LEE VALLEY REGIONAL PARK AUTHORITY

**REGENERATION AND PLANNING
COMMITTEE**

PLANNING CONSULTATION BY ENFIELD COUNCIL

**AT: LEE VALLEY GOLF COURSE AND CAMPING & CARAVAN PARK, 61
MERIDIAN WAY, EDMONTON, LONDON, N9 0AR**

Image from DAS showing Viewing Platform

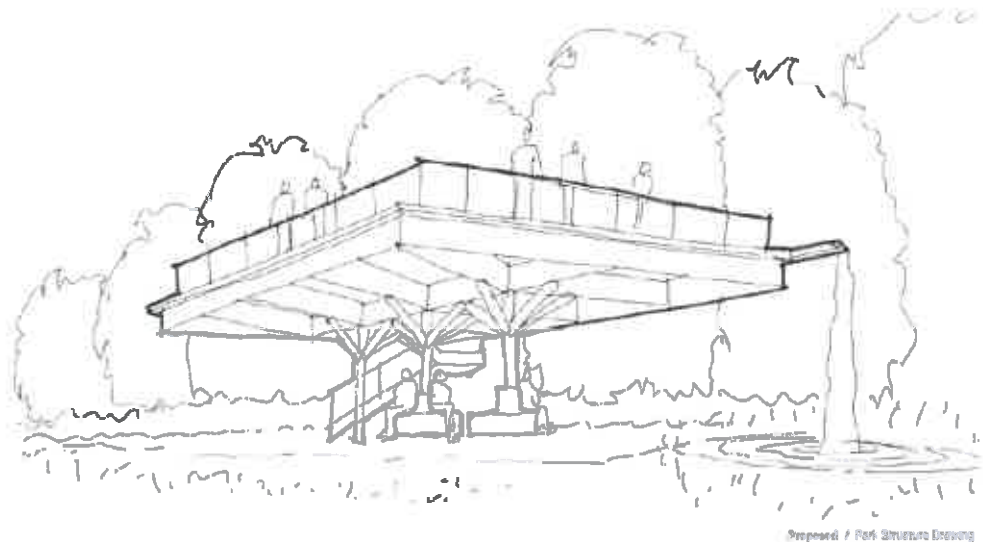
- would relate to the surrounding landscape; although the provision of an additional view point across the site could be seen as a positive it is not clear why there needs to be such a large raised structure in this location, given it sits on top of an existing mound ('The Wave Mound' as shown on the plans for the Community Park) from which there are views across the Park area.
